ection 16 Planning Application for Proposed House (Redevelopment) at Ref.: ADCL/PLG-10253/L				
Lot 110 in D.D. 219, Kei Pik Shan, Tai Chung Hau, Sai Kung, New Territories				
(Planning Application No. A/SK-PK/295)

Table | 1
Response-to-Comments

Figure: 2-l

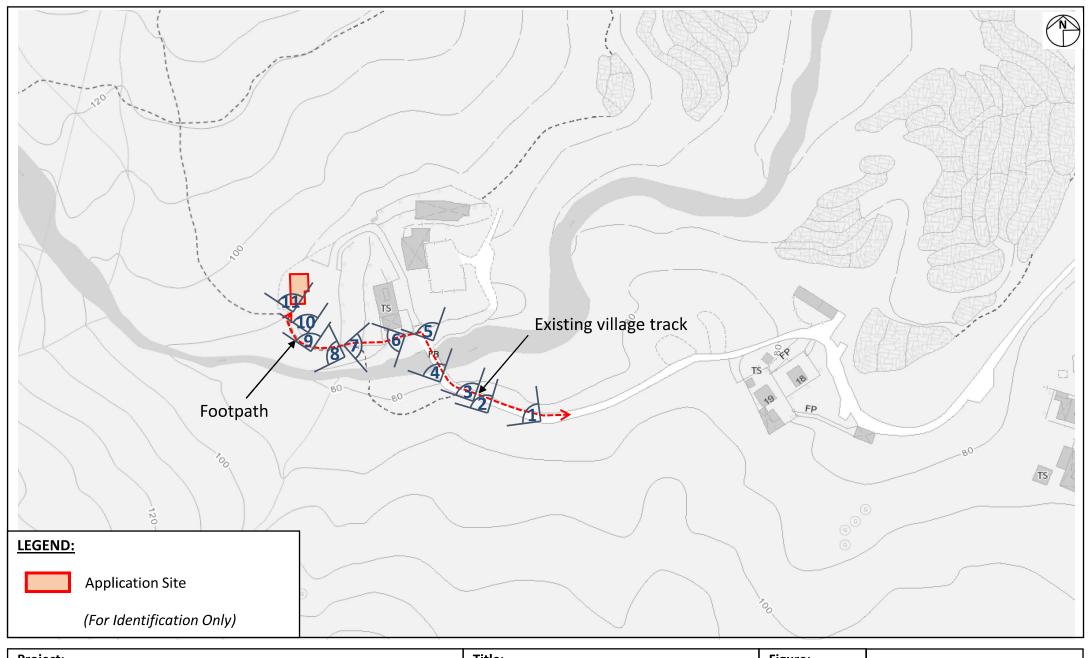
(b) in addition, "Footpath A" in Figure 2 of the planning statement wa observed to be blocked by a gate of nearby private lot, i.e. Lot 11: in D.D. 219, and the route of "Footpath B" will pass through a nearby watercourse. The applicant should provide more details or the expected method of access, e.g. site photos, and how construction materials and machinery will be delivered to the site with due consideration in preserving the nearby vegetation of environment.	considered as an alternative or secondary means of access. Please refer to revised Figure 2.I, Figure 2.II, Figure 2.III for the expected method of access. The application site is accessible via an existing footpath that passes through a footbridge over the watercourse. While the proposed house to be built is a small house of 48m² in area with 1 storey (not more

(c) according to para. 4.2.1 and Figure 2, the application site can be accessed via two footpaths. However, Footpath A will pass through Lot 111 in D.D. 219 which is fenced off, and Footpath B will pass through a watercourse without any bridges/connections. Please clarify the accessibility of the application site in this regard.	Please refer to revised Figure 2, Figure 2-I, Figure 2-II, Figure 2-III for the expected method of access. The application site is accessible via an existing footpath that passes through a footbridge over the watercourse.

Figure: 6

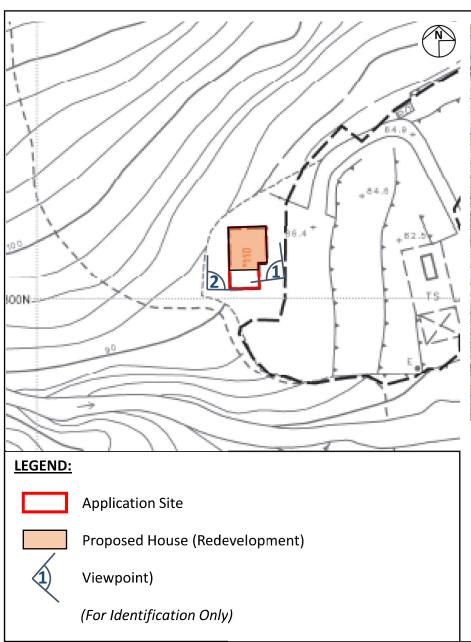
Department	Date	Comments	Responses to Departmental Comments
		ensure that the proposed drainage works and the downstream drainage systems have adequate capacity and are in good condition to accommodate all discharge water collected from his lot and all upstream catchments. The applicant shall be responsible to effect any subsequent upgrading of these proposed works and the downstream drainage systems in respect of design, construction and maintenance, as may be required by DLO/SK.	
Planning Department	11.7.2024	 (a) according to para. 1.2.4 and Appendix I, existing structures or ruins of the original house was identified on the application site. Please provide a plan showing the location(s) of the ruins identified; 	The location of the existing structures of the original house is presented in Figure 6.
